CITY OF  
ASHLAND

Date: June 8, 2020  
From: Scott Fleury PE, Interim Public Works Director  
To: Planning Commission  
RE: Grand Terrace Annexation-Transportation Commission Comments

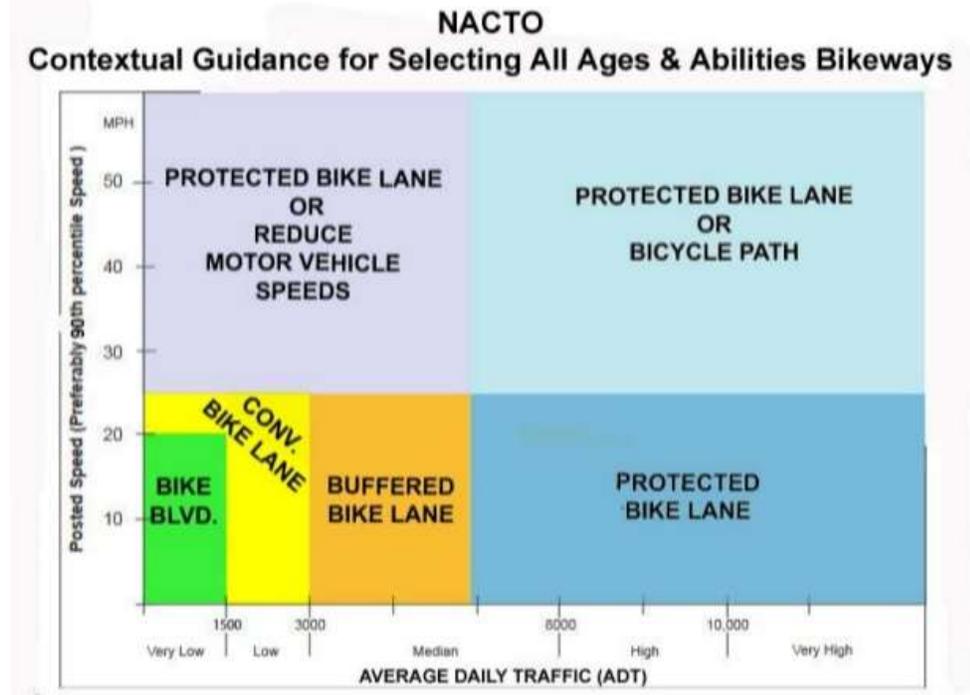
There is concern about egress from the proposed driveway location, specifically a left-hand turn movement heading northbound with limited site distance along with potential right-hand ingress movements occurring into the development. Appropriate signage and striping should be considered and installed to reduce conflicts and make drivers aware.
